**Chatham Airport Commission**

**Response to Dr. Michael Tompsett's Analysis  
"Less Safe Not More"**

## **Fact Check and Analysis Gale Associates**

*This document is a Fact Check and Response to an analysis made in October 2019 by Dr. Michael Tompsett, regarding proposals made by the Chatham Airport Commission to update the Master Plan for the Airport (AMPU). That analysis, entitled "Less Safe not More" was widely distributed to residents of Chatham, the Town Manager and Board of Selectmen. The Commission has requested Gale Associates, as aviation consultant, to examine the document and create the detailed and comprehensive review of the analysis, below.*

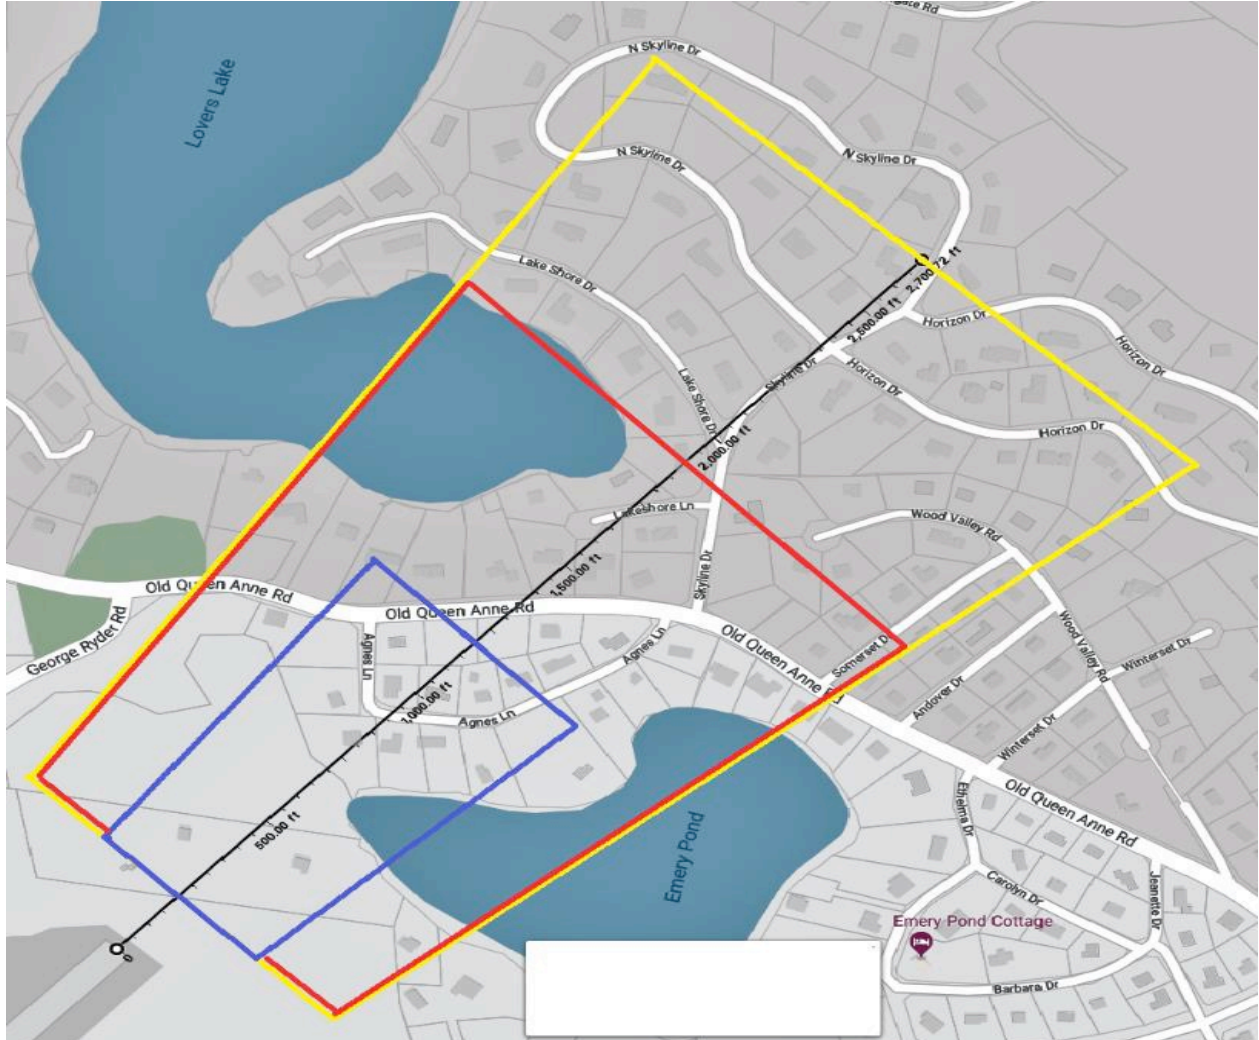
these zones have been heavily developed with stores, offices, apartments and 20 homes. However non-precision approaches without vertical guidance, and precision approaches with vertical guidance are regarded as much less safe by the FAA, which recommends areas much larger by 3.6 in orange, and 5.7 times in yellow respectively, in the figures below.

First, the Master Plan does not propose “precision approaches.” Second, the figure cited below is completely taken out of context and the author has inaccurately applied the wrong design aircraft in Table 3-5 *Runway Design Standards Matrix* of FAA AC 150/5300-13A, which results in an overstated Runway Protection Zone. This gives the illusion that the Airport would require RPZ's 3.6 to 5.7 times larger than they currently have. This has been proven inaccurate. This contradicts expert opinion of all competent, expert aviation authorities. The AMPU proposes recommended approaches that are much safer than those currently in use. These approaches are in use at thousands of small airports without a control tower. The larger runway protection zones cited by the author apply to airports with larger design aircraft and approaches with lower visibility minimums and do not apply in Chatham. FAA representatives have toured and inspected the airport on many occasions without any specific criticisms or comments about the RPZs. In addition, the FAA has denied any complaint about grant assurance violations by Chatham.

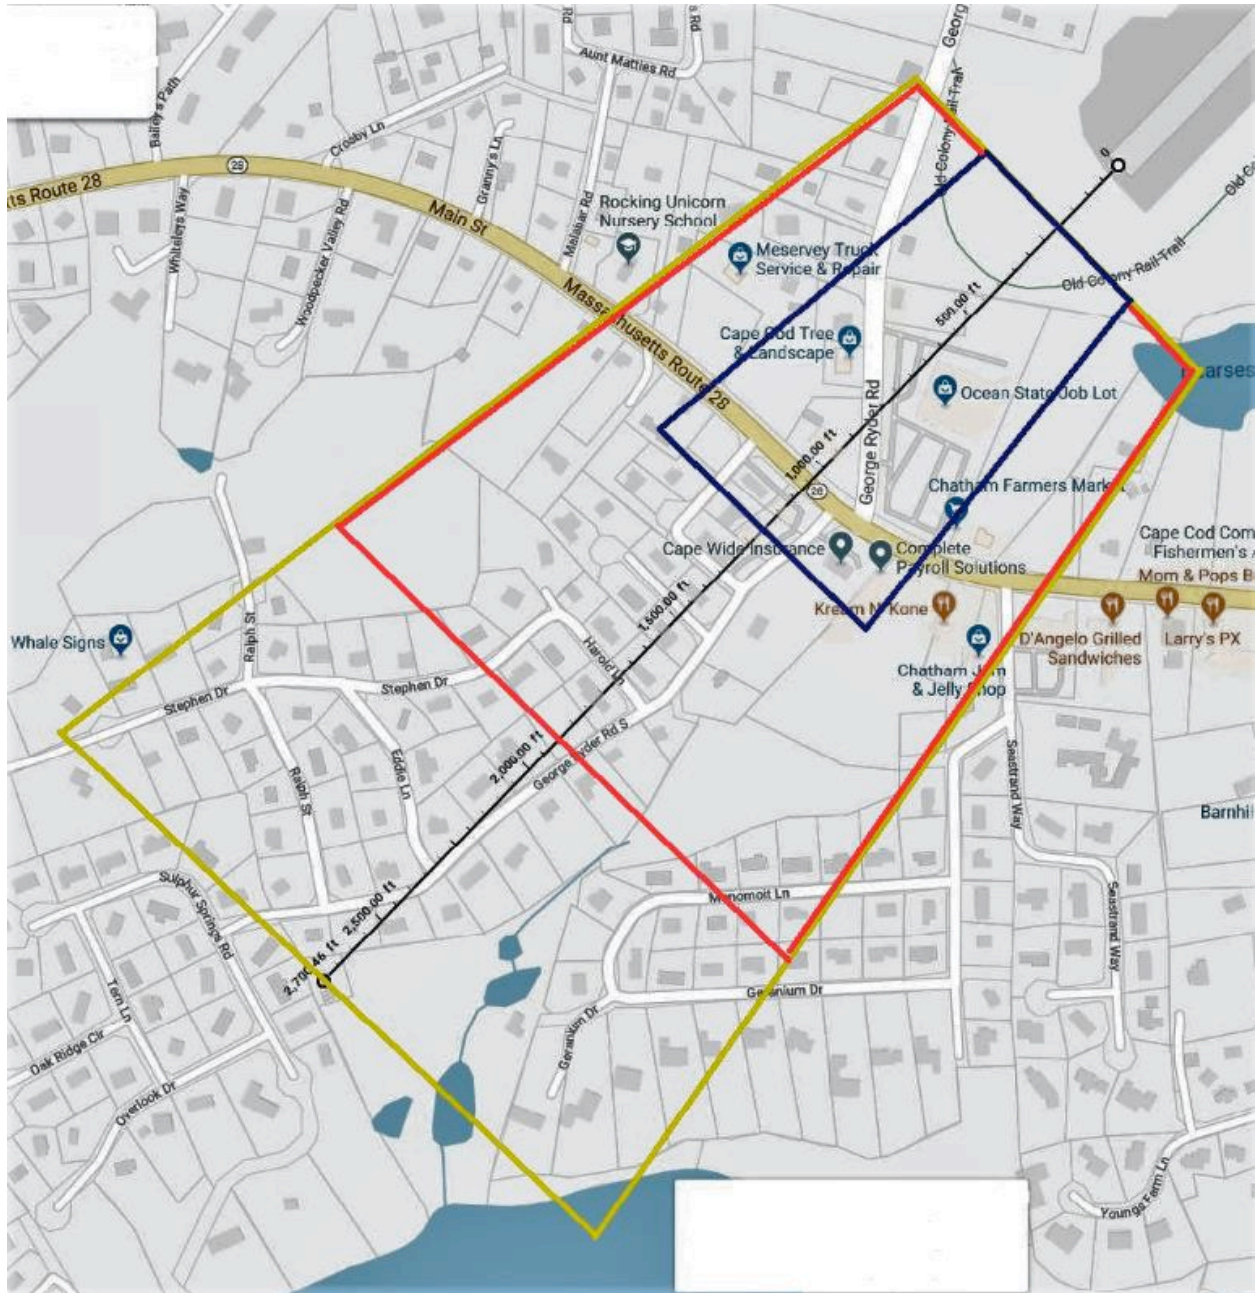
The graphic below incorrectly displays the extent of the RPZ at the Rwy 24 end as it is based upon an incorrect assumption of a change in Design Aircraft (which is not proposed) to one that cannot be accommodated at Chatham Municipal Airport.

The graphic below incorrectly displays the extent of the RPZ at the Rwy 6 end as it is based upon an incorrect assumption of a change in Design Aircraft (which is not proposed) to one that cannot be accommodated at Chatham Municipal Airport.
